## **LIPSCOMB LANDING ESTATES SUBDIVISION**

APPLICATION NUMBER 10 DATE October 19, 2017

REQUEST Subdivision

# DETAIL SITE PLAN

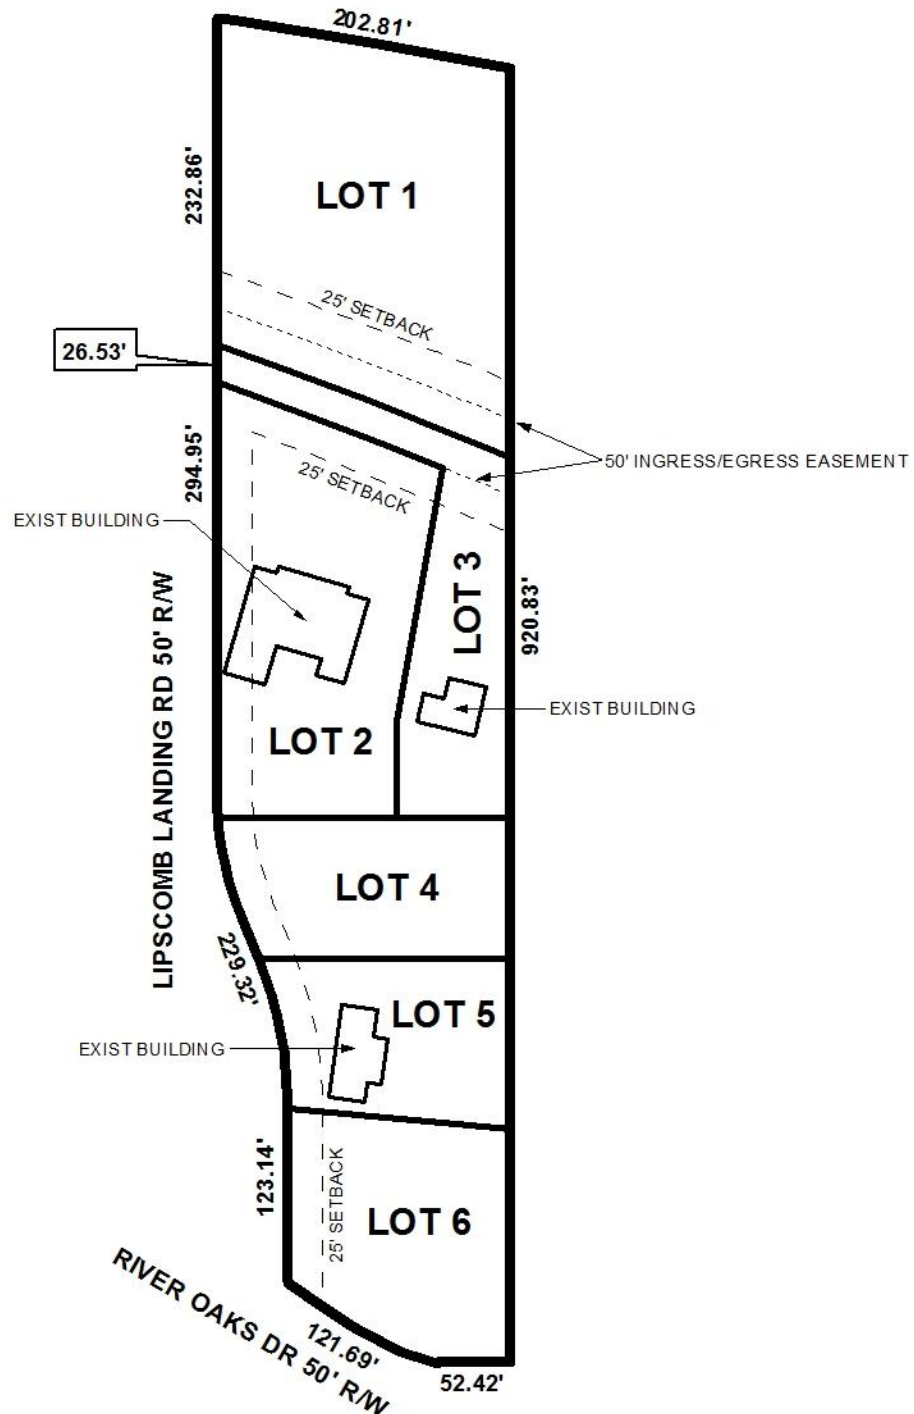
The preliminary plat submitted for the current application depicts a 50' easement for ingress/egress, and appears to be depicted as a private street as it is depicted as extending onto the adjacent property as the previously approved private street did. It should be noted that if the previously approved street were to not be constructed, several parcels would remain landlocked as they are currently. Per Section V.D.4. of the Subdivision Regulations, all lots should have frontage on either a private or public street, therefore, it may be appropriate to holdover this application to allow the applicant to submit a revised Subdivision application to include all properties previously approved to be served by the private street as well as a new Planned Unit Development application.

The 25' minimum building setback is illustrated along both Lipscomb Landing and the proposed ingress/egress easement. Lipscomb Landing is a minor street without curb and gutter, and is illustrated as having existing 50' right-of-way, where a 60' right-of-way is typically required for such a street. While dedication would typically be required, this would result in an existing dwelling on the proposed Lot 2 being partly located within the right-of-way. If approved, an increased setback should be illustrated to accommodate the future right-of-way. The minimum building setback line should be adjusted an additional 5 feet.

It should also be noted that the proposed Lot 3 is a flag lot that is 56'± wide at the 25' setback, and as such, exceeds the maximum width-to-depth ratio of V.D.3. of the Subdivision Regulations. There are very few flag lots in the area, and those that are legal lots of record have water frontage, whereas the proposed flag lot does not. The applicant should provide justification for the proposed Lot 3 to be a flag lot that exceeds the maximum width-to-depth ratio.

With regards to access management, a note should be placed on the Final Plat, if approved, stating each lot is limited to one curb cut to either Lipscomb Landing or the proposed private street, with any changes in its size, location or design to be approved by Traffic Engineering and conform to AASHTO standards.

- 1) provide justification for the approval of the proposed Lot 3 to be a flag lot that exceeds the maximum width-to-depth ratio of V.D.3. of the Subdivision Regulations;
- 2) submittal of a revised Subdivision and Planned Unit Development application including appropriate fees.
